A3. Community Liaison Committee (CLC)

LIST OF INVITEES AND MEMBERS

Community Liaison Committee Invitee Member List

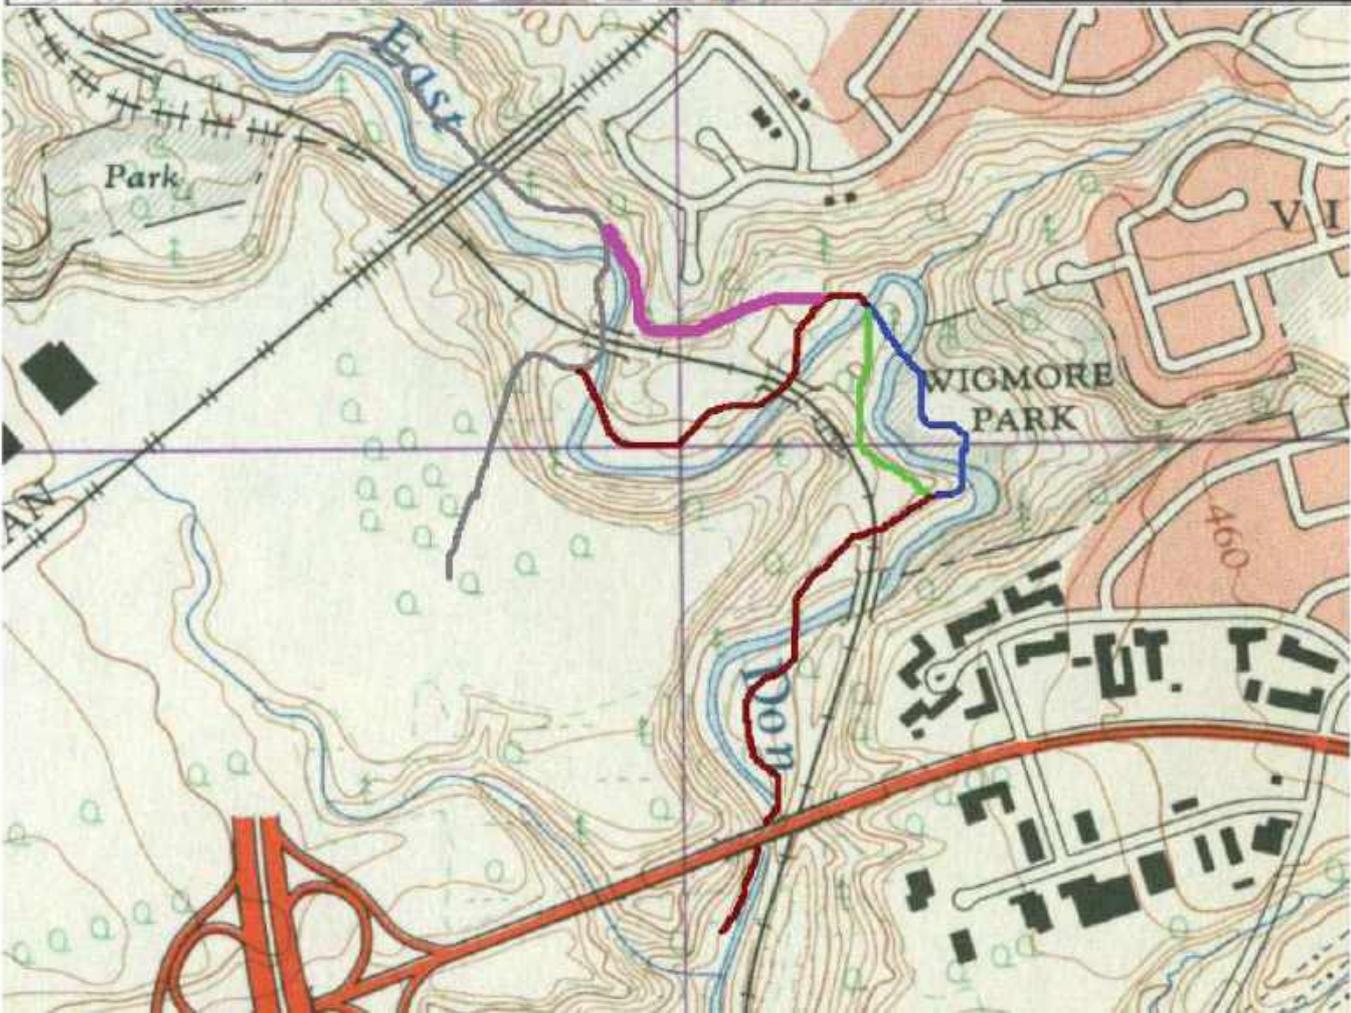
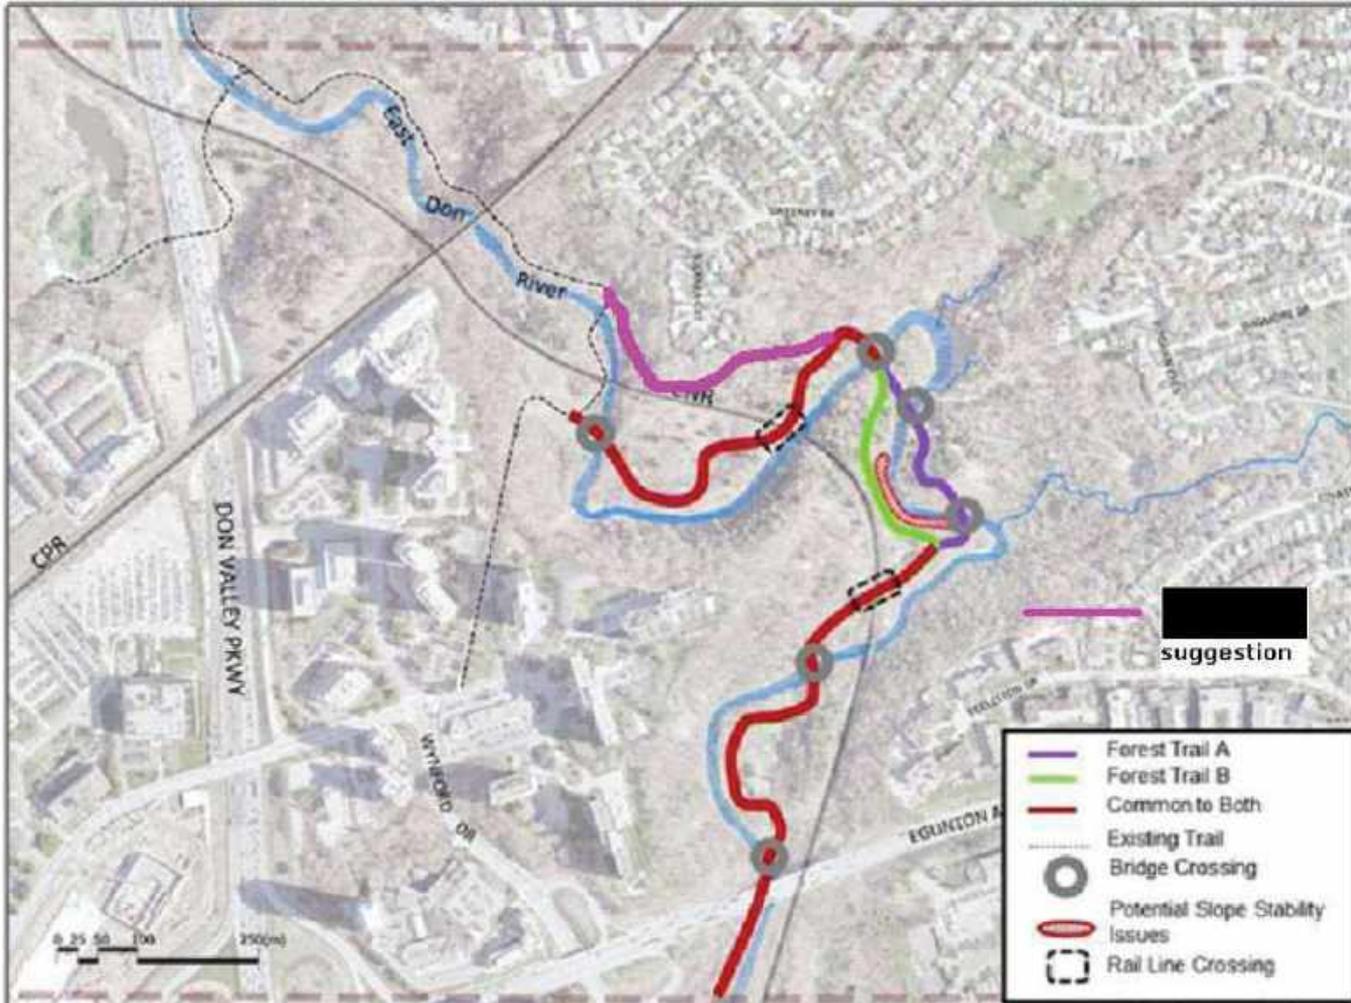
Area 3: Alternative access route B. At the south end, Taylor Massey Creek is already bridged by concrete pipes, so really only one new bridge is needed.

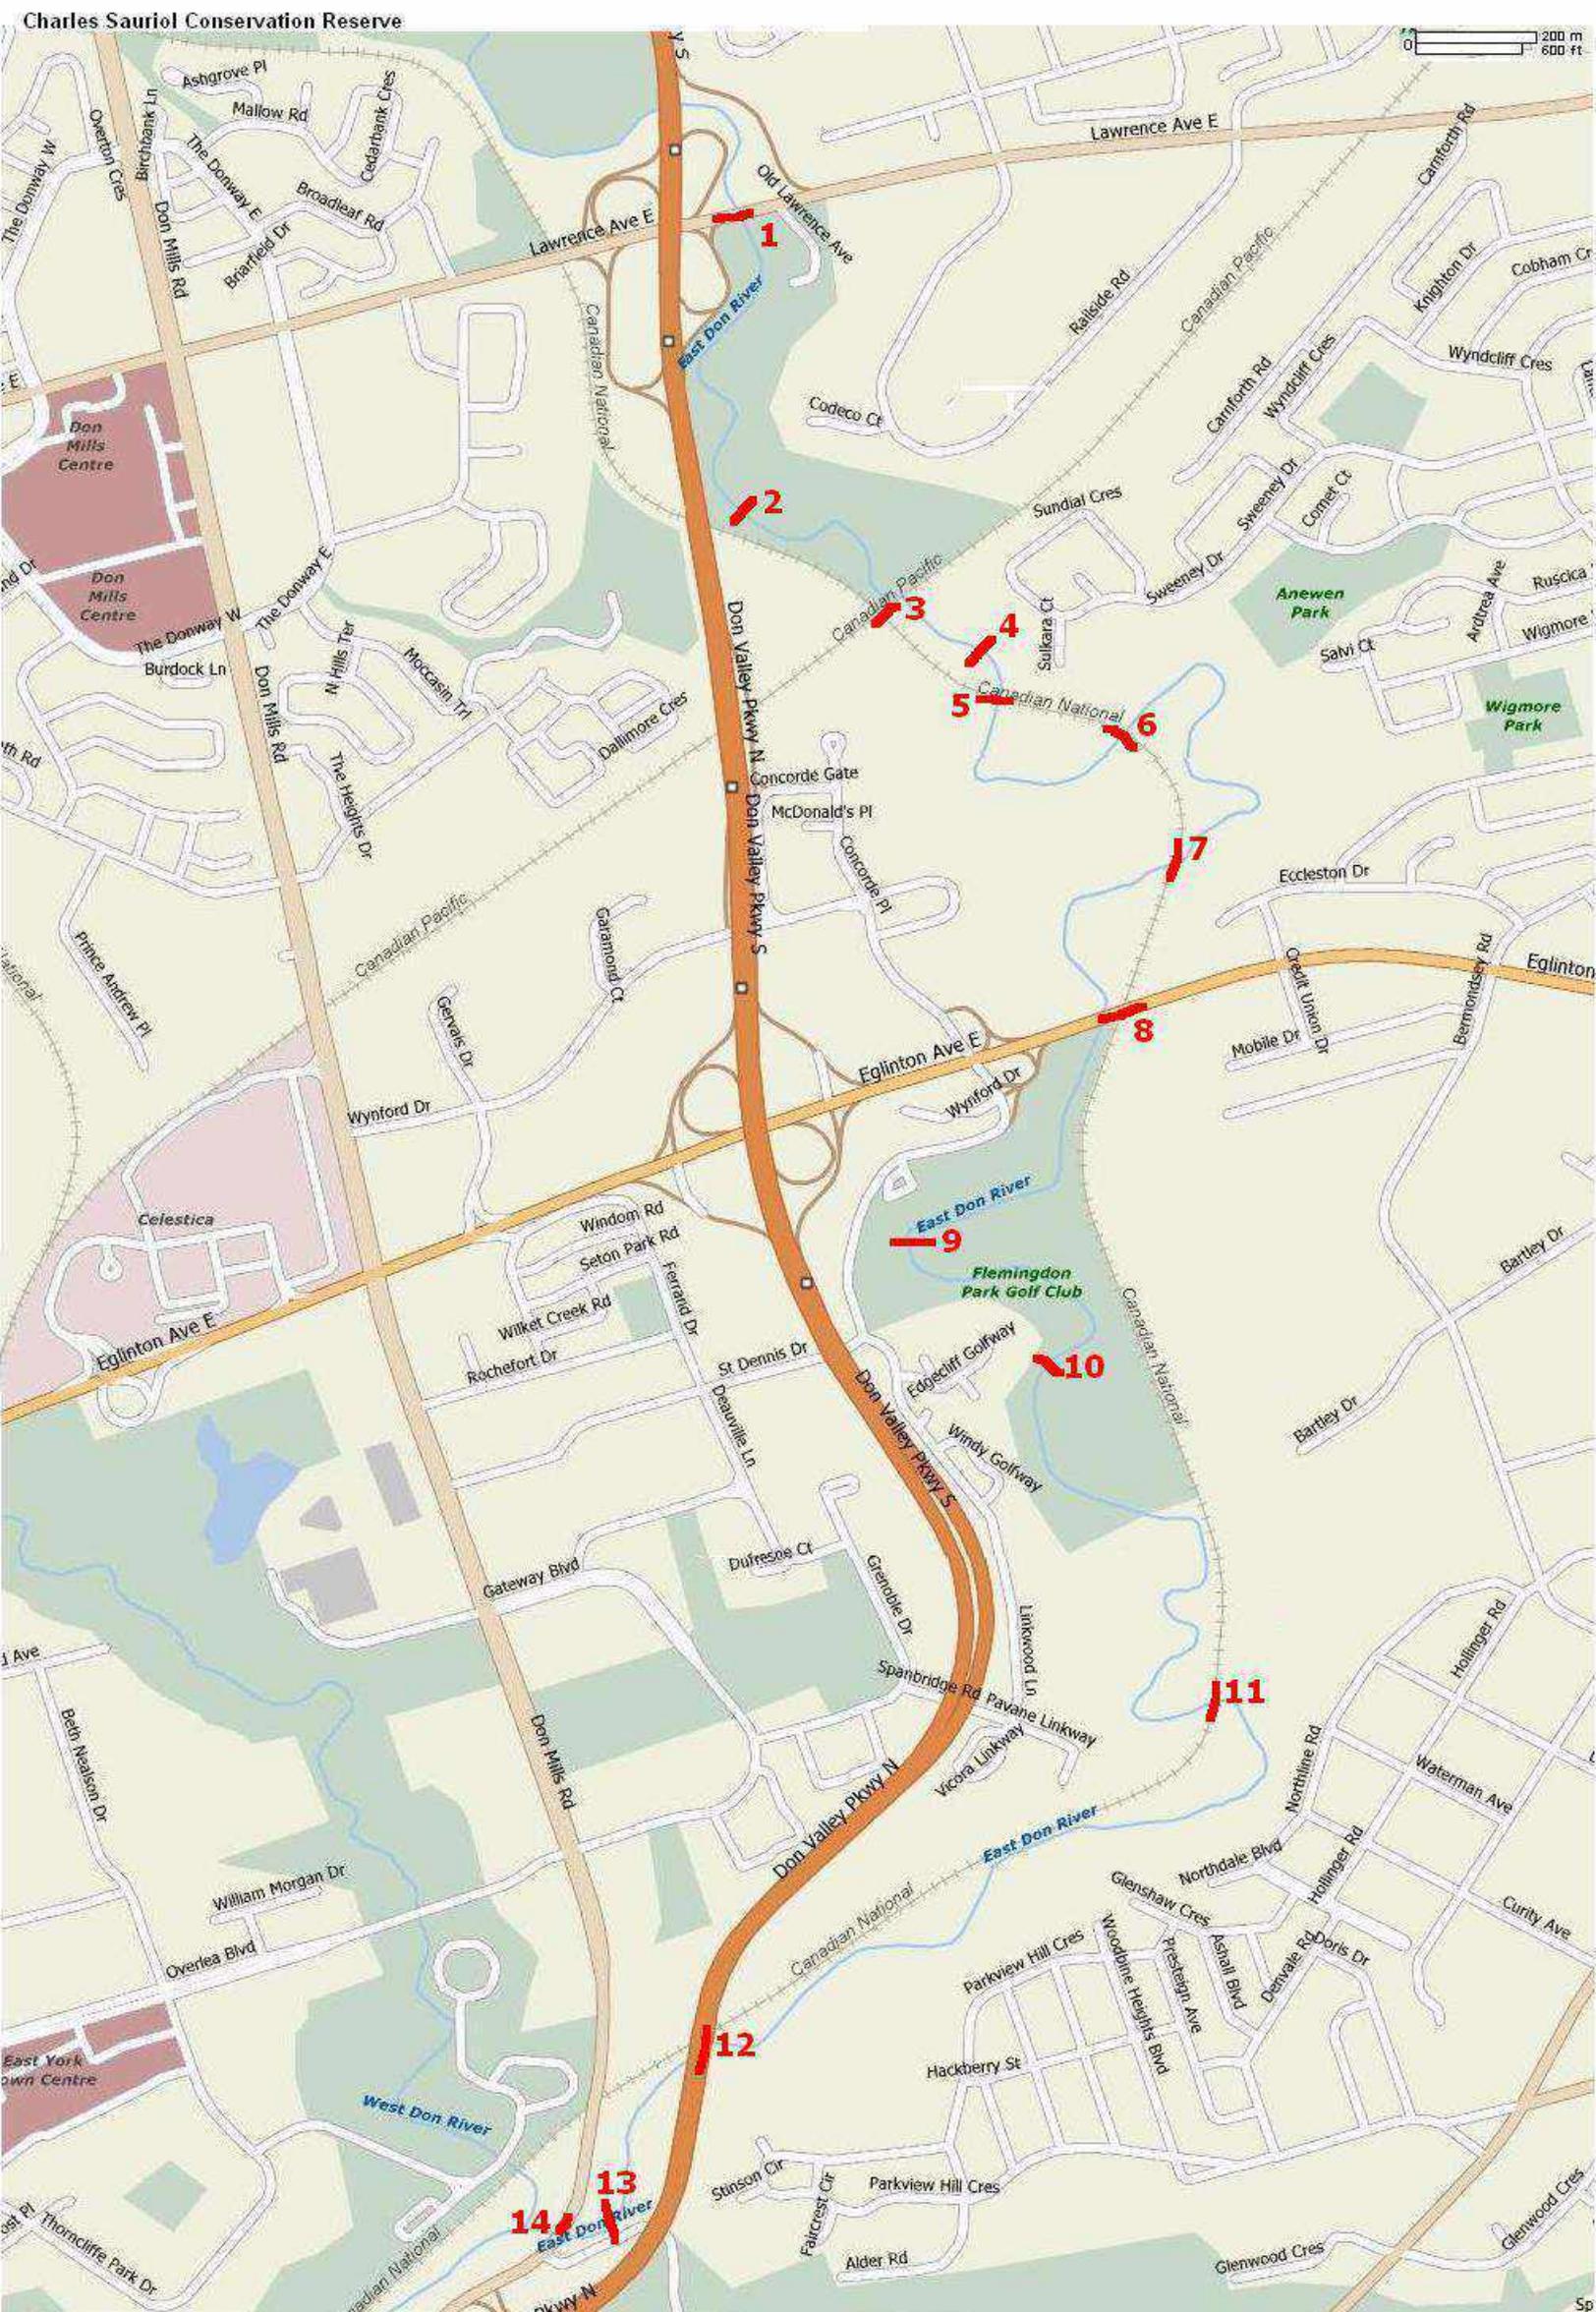
Thank you for the advance notice of the CLC meeting for the Environmental Assessment of the East Don Trail. I have marked Thursday March 6, 6:30 pm in my calendar. It was also good to get your e-mail of January 8 with the comments on the BEI. I still assert that there are 14 crossings of the East Don in the area (response 28), shown on the attached map csaur14.jpg.

Scale 1:4000

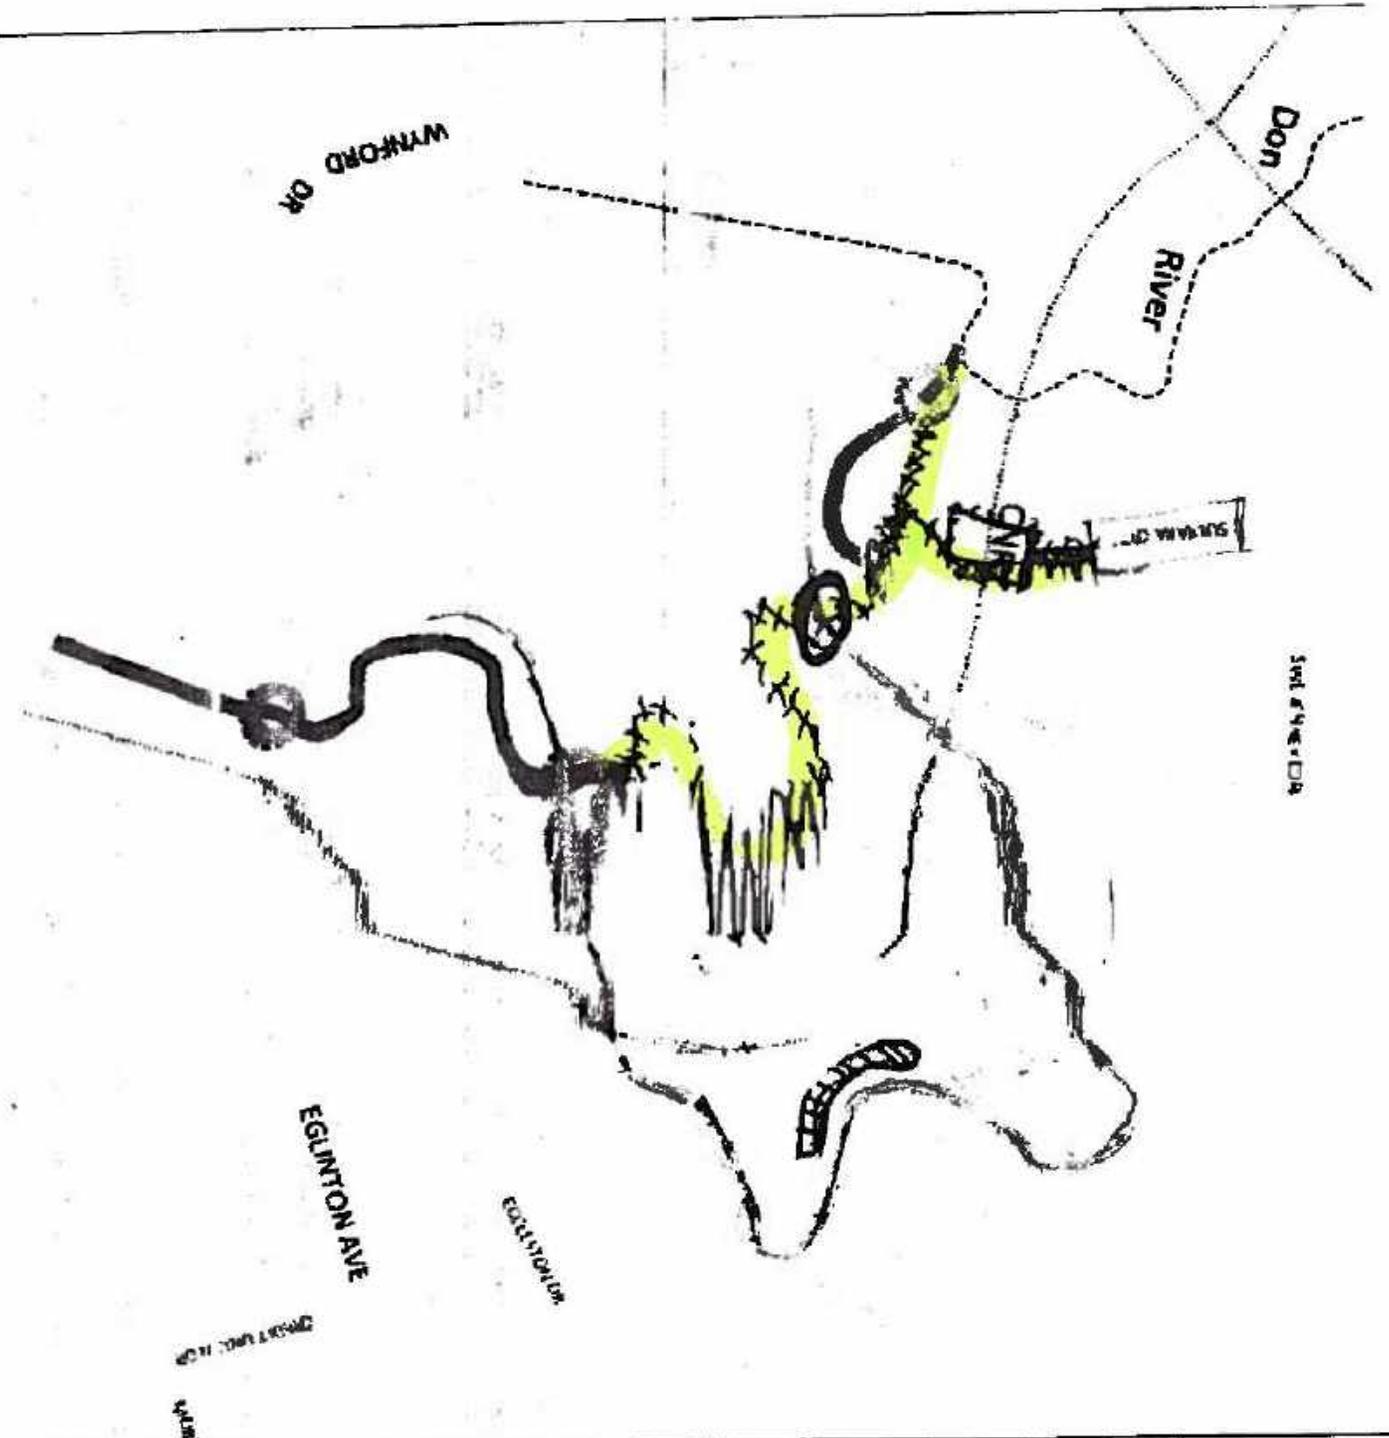
From: Natalie Seniuk/TRCA
To: Natalie Seniuk/TRCA@MTRCA,
Cc: Violetta Tkaczuk/TRCA@MTRCA
Date: 07/30/2013 11:33 AM
Subject: East Don Trail - CLC Meeting #4 Date & CLC Meeting #3 Draft Notes
